#### Author response:

#### RC1 response

## RC2 response

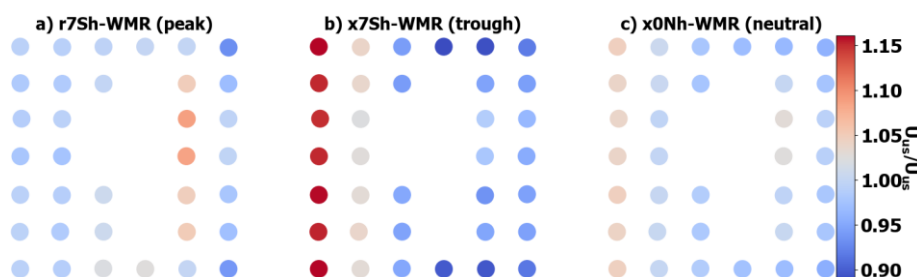
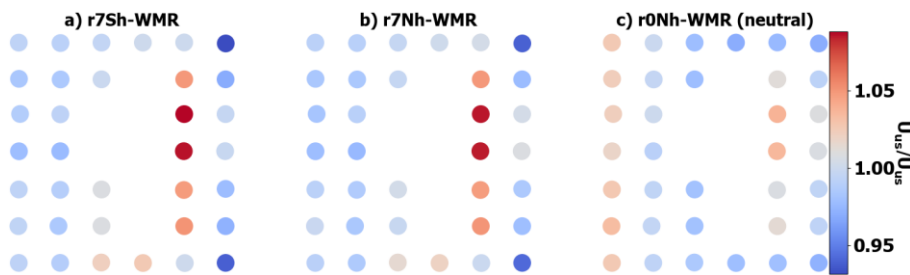
3. Line 312: “Notably, there is a TLW peak upstream of the hill in Fig. 10b”, can you label that in the plot?

Labelled as suggested.
